ECN/PCN No.: M1103

For Manufacturer		
Product Description: 10/100Base-TX RJ45, Tab Down, LED	Abraccon Part Number / Part Series: ARJC02-111009D	<input type="checkbox"/> Series <input checked="" type="checkbox"/> Part Number
Affected Revision: A	New Revision: B	Application: <input type="checkbox"/> Safety <input checked="" type="checkbox"/> Non-Safety

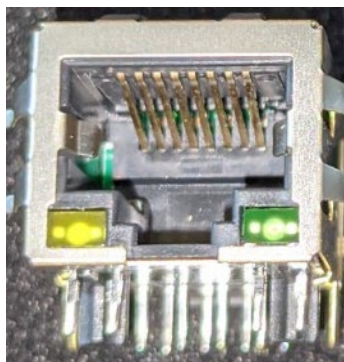
Front (Faceplate) – Front faceplate and LEDs of the original production line.

Part Marking – Marking appears on the back-side of the device and marked using ink. (part number shown is for illustration only).

EMI Fingers – fingertips flare outward from body.

Board Guides – round board guides

Front (Faceplate) – Front faceplate and LEDs of the new production line. LED lenses are slightly more diffused than original production line. This may cause slight variations in luminosity.

Part Marking – Part number will appear on top of device and laser marked (part number shown is for illustration only).

EMI Fingers – fingertips flare inward towards body.

Board Guides – Star board guides

Standard product review. Increased manufacturing lines to support volume.

The changes described here do not negatively impact form, fit or function of the device. Device outline, mechanical dimensions, internal schematic and electrical performance remain identical.
